2026 SINGAPORE GRAND PRIX

From	The FIA Formula 1 Media Delegate	Document	9
To	All Teams, All Officials	Date	09 October 2026
		Time	13:53

Title Car Presentation Submissions

Car Presentation – Singapore Grand Prix McLaren Mastercard F1 Team

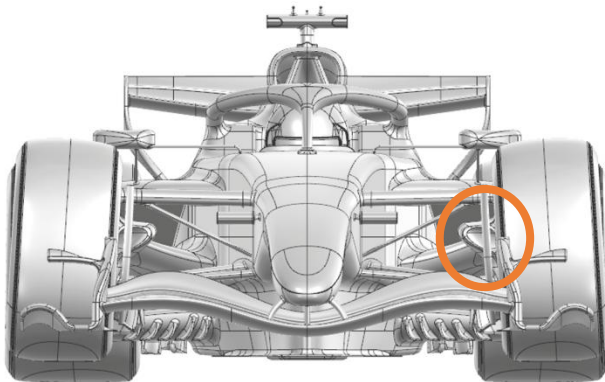
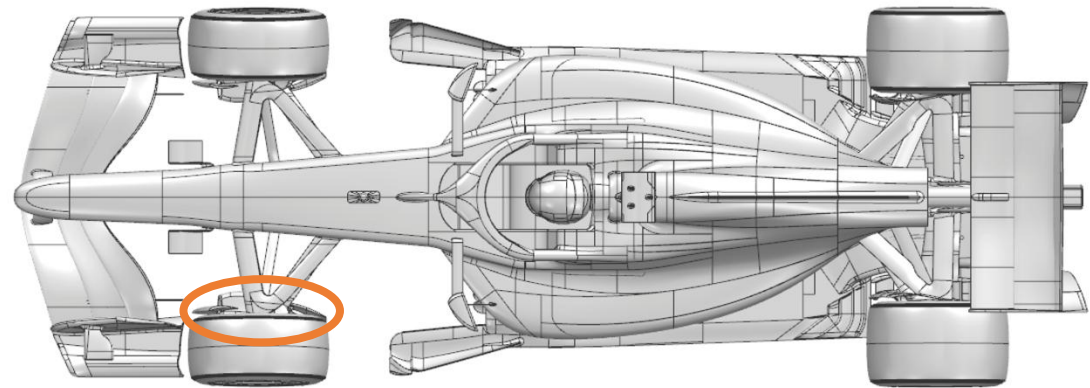
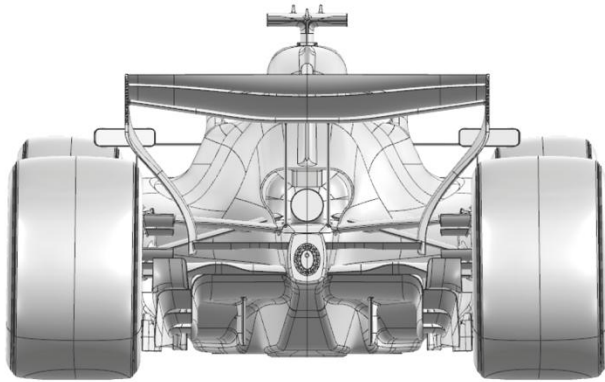
Updated component	Primary reason for update	Geometric differences compared to previous version	Brief description on how the update works (min 20, max 100 words)
1	Front Corner	Circuit specific - Cooling Range	High Cooling Front Brake Duct	To meet the high brake cooling demands of this and upcoming circuits, a new front brake duct aiming at increased brake cooling massflow has been designed.

Car Presentation – 2026 Singapore Grand Prix Mercedes-AMG PETRONAS F1 Team

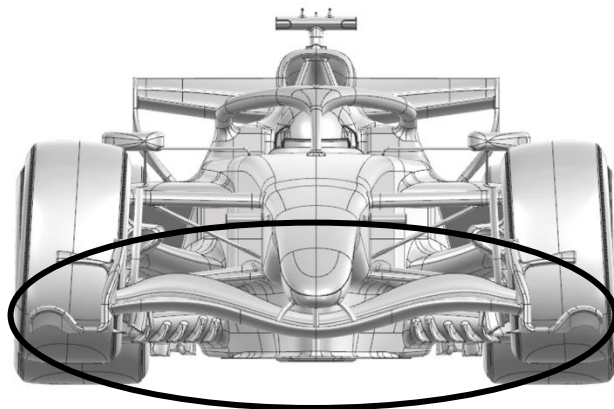
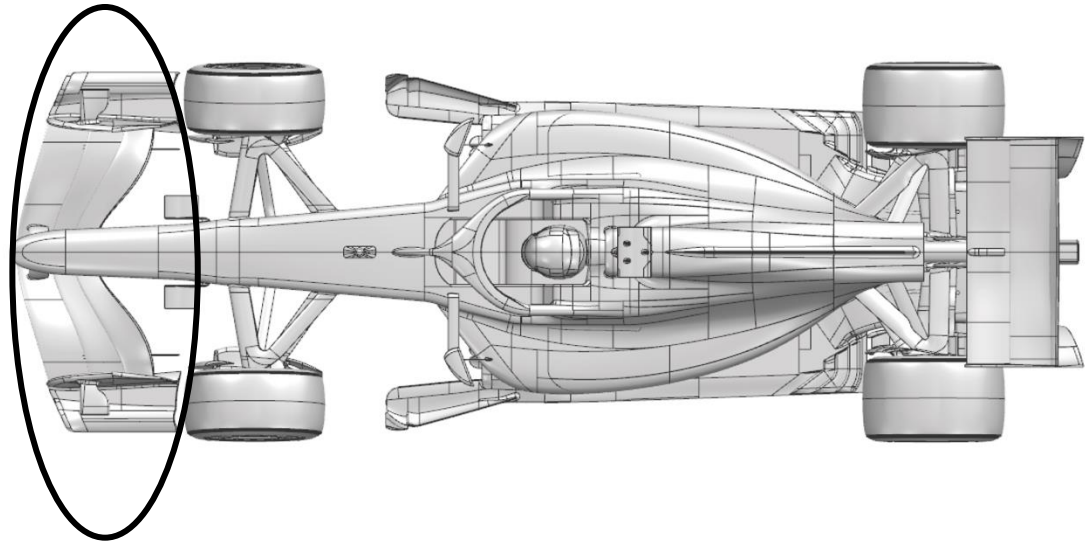
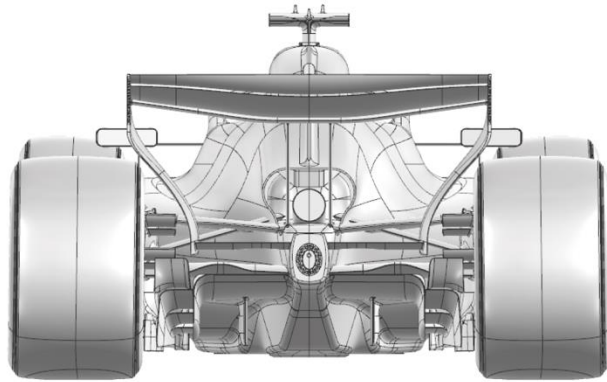
Updated component	Primary reason for update	Geometric differences compared to previous version	Brief description on how the update works (min 20, max 100 words)
1	Front Wing	Performance - Flow Conditioning	Change in chord distribution between three wing elements; switch to two element SM	Change in chordwise and spanwise loading, results in improved performance across the operating envelope, including improved front tyre wake control.
2	Front Wing Endplate	Performance - Flow Conditioning	Front wing endplate and footplate adjusted to accommodate the above. Diveplane camber adjusted.

Car Presentation – Singapore Grand Prix Oracle Red Bull Racing

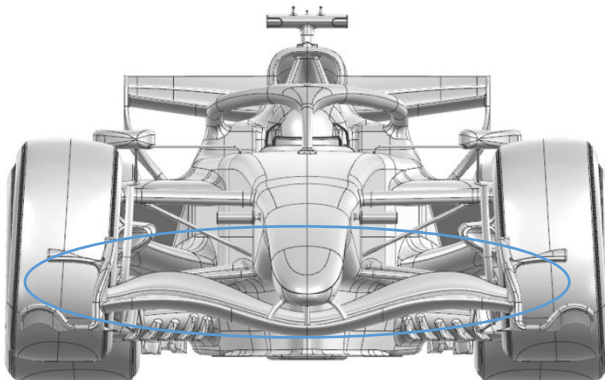
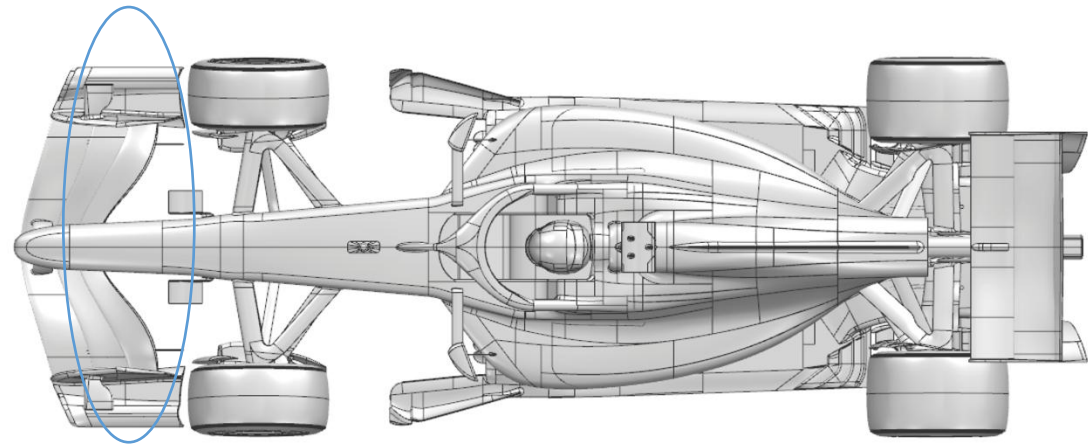
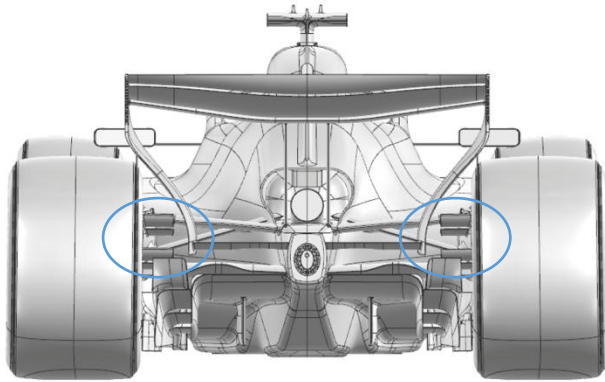
Updated component	Primary reason for update	Geometric differences compared to previous version	Brief description on how the update works (min 20, max 100 words)
1	Front wing	Performance - Local Load	Revised end plate and flap geometries	A new wing design has been achieved by modifying a previous front wing assembly, which has been further optimised to offer more local load whilst maintaining the flow stability.
2	Rear Wheel Bodywork	Reliability	Enlarged exit duct	By modifying existing parts, a larger exit duct has been achieved for more cooling flow to cope with the anticipated brake energy of the Singapore circuit
